Development Permit No.: D/169-2022

YAAMBA ROAD RETAIL

Traffic Impact Assessment

RE: Response to Information Request (D/169-2022) 353 Yaamba Road, Park Avenue

FIGURE 1 – PROPOSED ACCESS ARRANGEMENTS OFF MAIN STREET

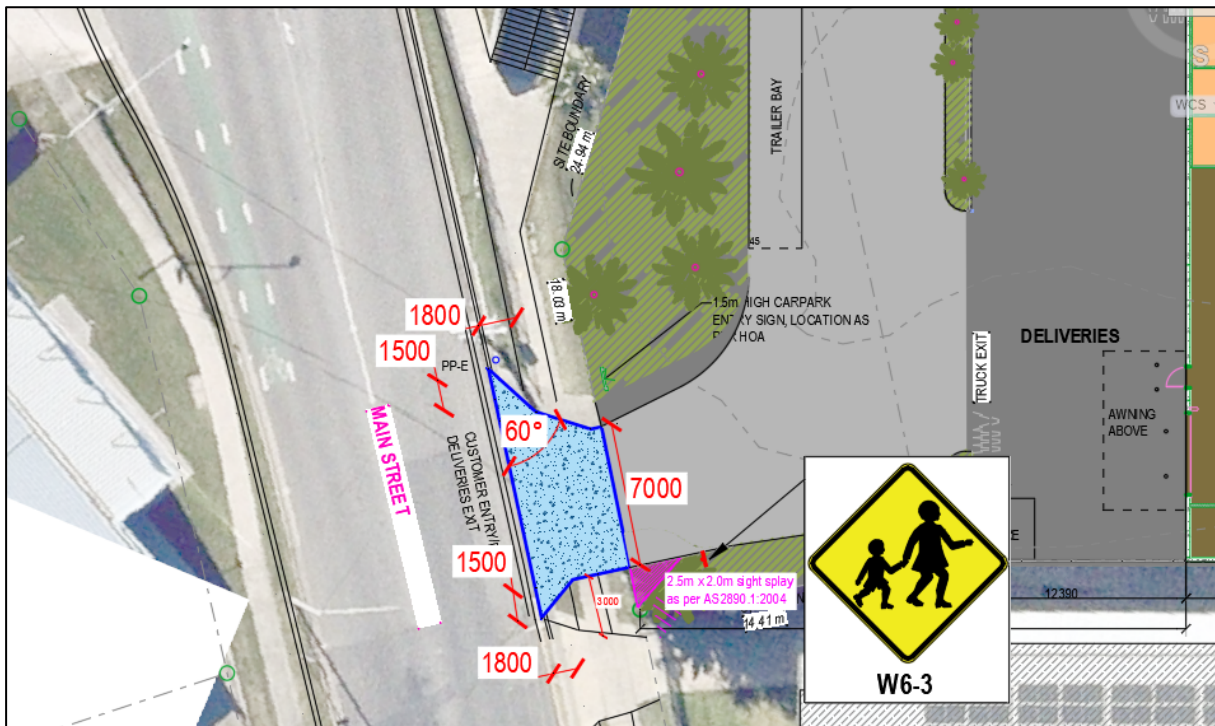
Please provide certification of the Traffic Impact Assessment by a Registered Professional Engineer of Queensland (RPEQ).

As shown in Figure 1, the proposed access has been designed in accordance with AS2890.1:20004, allowing sufficient view lines to be achieved between a pedestrian walking along the frontage and driver exiting the site. Furthermore, it is proposed that a supplementary warning sign be erected just inside the development on the egress approach to warn traffic of the potential for children crossing the driveway.
